DA 2011/109 - 6-12 COURALLIE AVENUE, HOMEBUSH WEST

SUMMARY	
PROPERTY:	6-12 Courallie Avenue, Homebush West
LOT & DP:	Lots 3, Lot 4, Lot 5, and Lot 6 in DP 11427
DA NO.:	2011/109
APPLICATION TYPE:	Residential Flat Building
REPORT BY:	Penny Anson
REFERRED TO JRPP:	Yes (Capital Investment Value >\$10 million)
RECOMMENDATION:	REFUSAL
SUBMISSIONS:	Seven (7) written submissions were received
ZONING:	Residential 2(b)
DATE APPLICATION LODGED:	21 June 2011
APPLICANT:	Kin Wai Chan (PCArch Pty Ltd)
OWNERS:	Kean Kap Lee, JHB Developments & Maxum Investments Pty Ltd

Approval is sought for the demolition of existing structures and construction of a five (5) storey residential flat building accommodating 49 apartments, 83 off street parking spaces at basement level and strata subdivision.

Figure Two: Appendix 1 Maps – Part C Strathfield Consolidated Development Control Plan 2005.

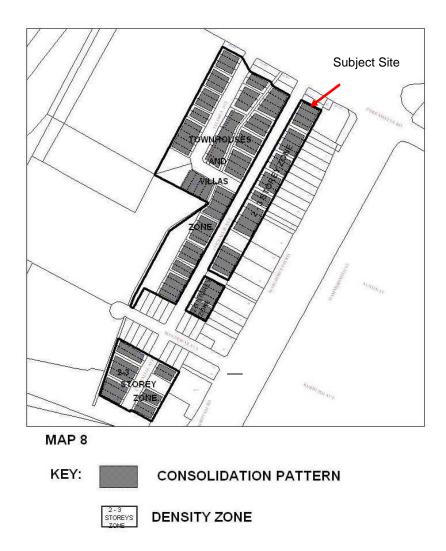
The Courallie Avenue streetscape is in transition. The west side of the street accommodates single storey detached dwellings and is zoned for town house and villa development (refer Figure Two). The west side of Courallie Ave is flood affected.

The proposal is contrary to built form guidelines in the Residential Flat Design Code and the principles of SEPP 65 relating to context bulk and scale. The SCDCP - Part C (refer Figure Two) restricts development to three (3) storeys along the western side of Courallie Avenue with four (4) to five (5) storey development permissible on Marlborough Road and within the Parramatta Road corridor only where taller buildings do not appear out of scale relative to the width of the street.
